# Product Change Notification (PCN)

PCN Number	501666	Date Issued	November 07, 2016
Reason for Change	Obsolete		
Change Type Description	This is to inform you that the part(s) referenced in this notice will be made obsolete due to low demand. Please contact your Molex Sales Engineer for additional questions concerning possible replacement part(s).		
Planned Implementation Date	September 12, 2017		
Last Time Buy Date for Obsolete Parts	June 12, 2017		
Last Time Ship Date for Obsolete Parts	September 12, 2017

33482-0801

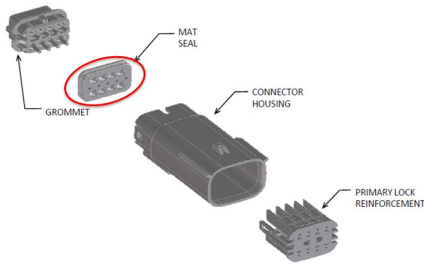
- For continuous improvement, Molex will be upgrading the Mat Seal within the MX150 2x4 Blade for seal tear reduction
- Product Impact
  - Mat seal hole geometry and hole location optimization
  - Seal color change from rust red to royal blue
  - No change to hole diameter
  - Material will remain the same inherently lubricated silicone
- Part Number Impact
  - 33482-08xx will become obsolete, replaced by 33482-48xx
- PPAP and samples available upon request
